[Docket No. FAA-2006-23871; Directorate  
Identifier 2006-NE-01-AD]

#### Airworthiness Directives; General Electric Company (GE) CF6-80C2 Turbofan Engines

**ACTION:** Notice of proposed rulemaking  
(NPRM).

Location of Forward Engine Mount Platform and Forward Engine Mount Yoke  
Figure 1

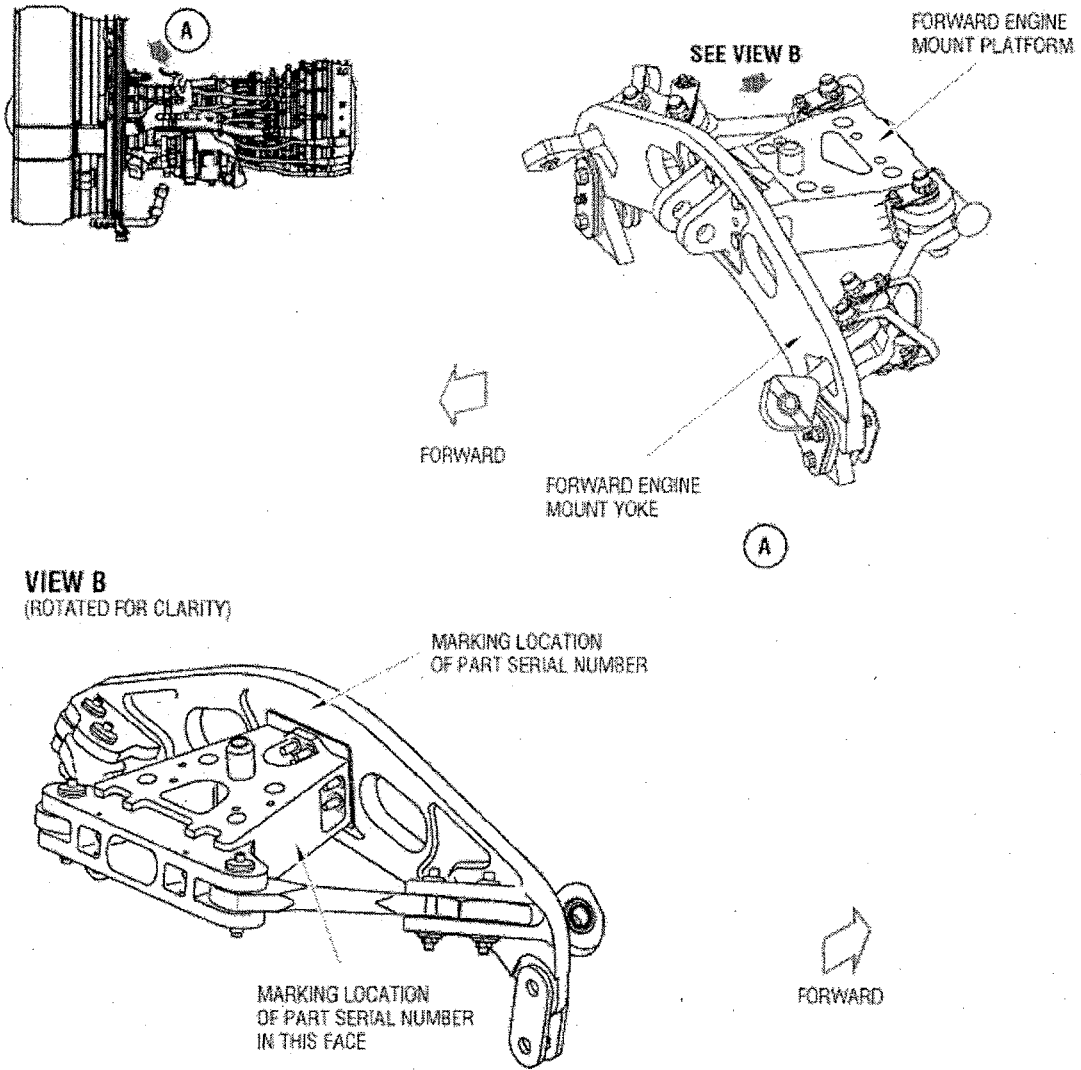
(n) Replace the affected forward engine mount platform and or the affected forward engine mount yoke with a non-weld-repaired cast titanium forward engine mount platform and or the forward engine mount yoke or a forged titanium forward engine mount platform or a forged titanium forward engine mount yoke.

(p) Location of the forward engine mount platform and forward engine mount yoke and SN are illustrated in the following Figure 1.
